FINAL
YEAR 2 (2017) ANNUAL
MONITORING REPORT

**NEIGHBORS BRANCH/WALTON CRAWLEY BRANCH
STREAM & WETLAND RESTORATION SITE**

RE: Neighbors Branch/ Walton Crawley Branch Monitoring (DMS Project # 92879, Contract # D09023S)
Final Year 2 (2017) Annual Monitoring Report

Axiom Environmental, Inc. (AXE) is pleased to provide you with three hard copies and one cd of electronic files for the Final Neighbors Branch/ Walton Crawley Branch Year 2 (2017) Annual Monitoring Report. We received your comments via email on December 4, 2017 and have addressed them as follows.

Neighbors Branch Groundwater Gauge 1 Year 2 (2017 Data)

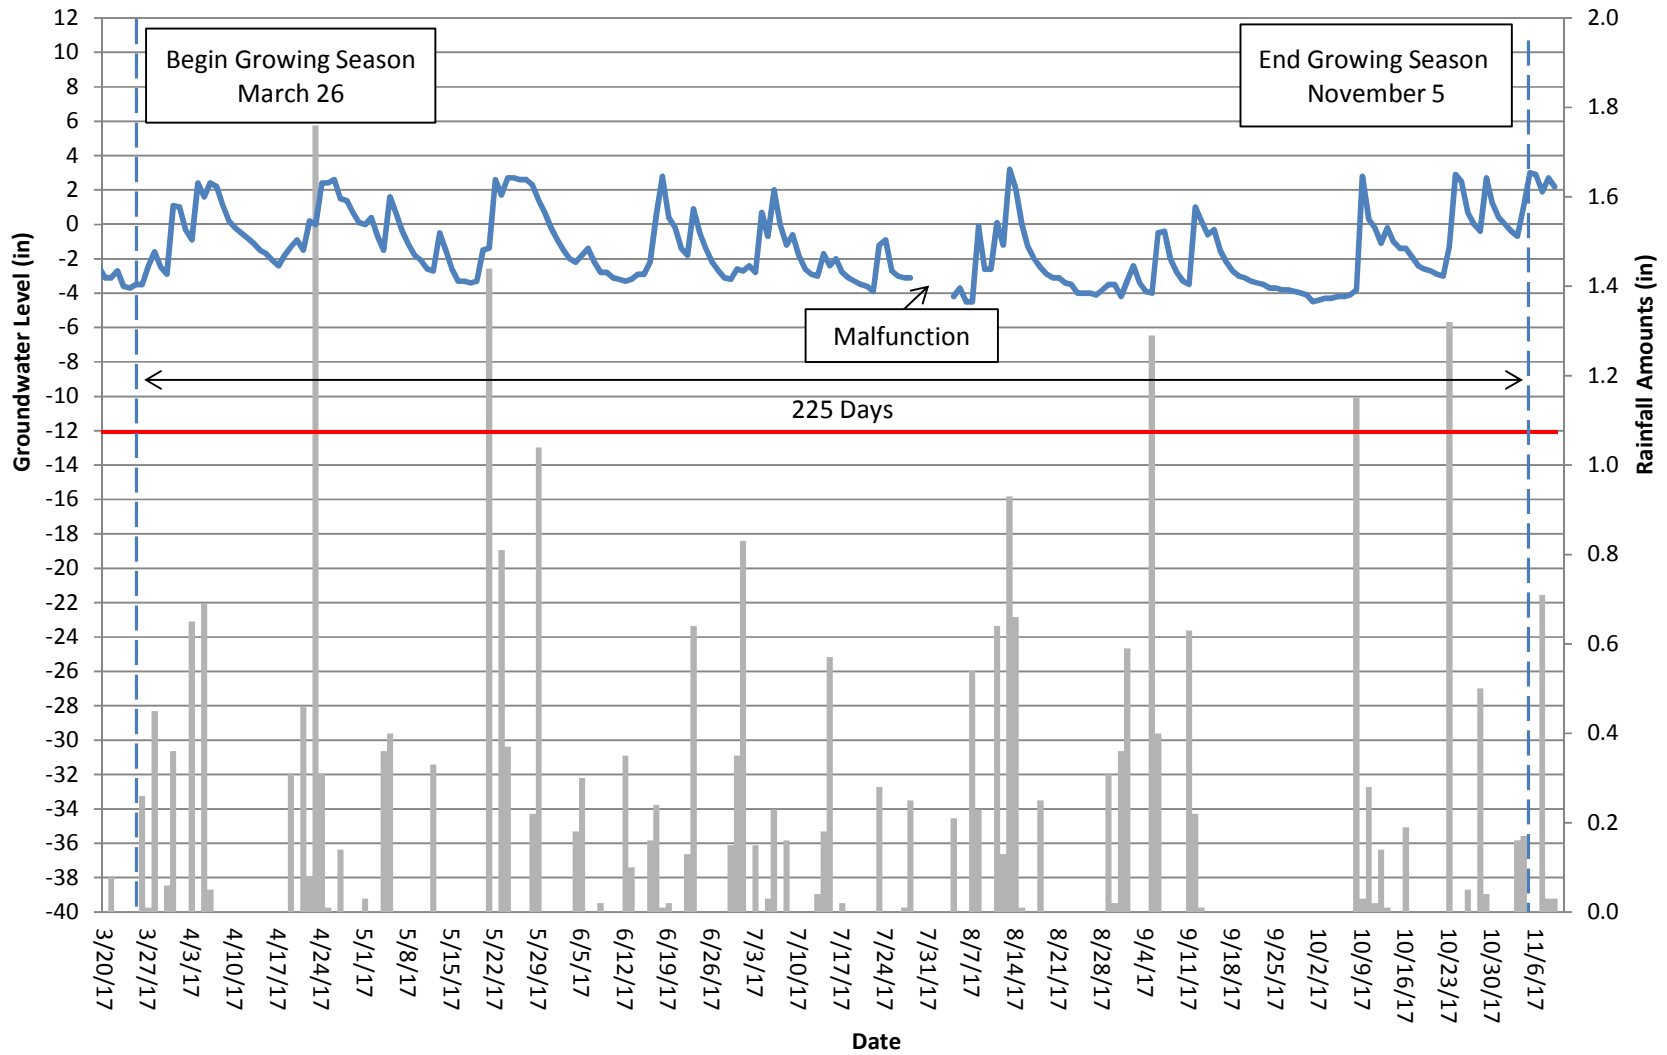
- Wetland Hydrology: Report indicates that Gauge 1 malfunctioned during the growing season. Has the gauge been replaced or repaired? Please add a statement in this section stating the corrective action and that the gauge is functioning correctly.
The wetland hydrology discussion was updated to read as follows: "Gauge 1 malfunctioned for 6 days (July 29 to August 3, 2017) during the growing season. It is unclear why the gauge was not taking measurements during this time, but it appeared to be functioning properly before and after the malfunction, and it was checked and reset at the time of the next data download. The gauge had no more issues for the remainder of the growing season. Based on precipitation data as well as data from Gauge 2, it is expected that this gauge would have continued to be saturated/inundated during this 6 day period."
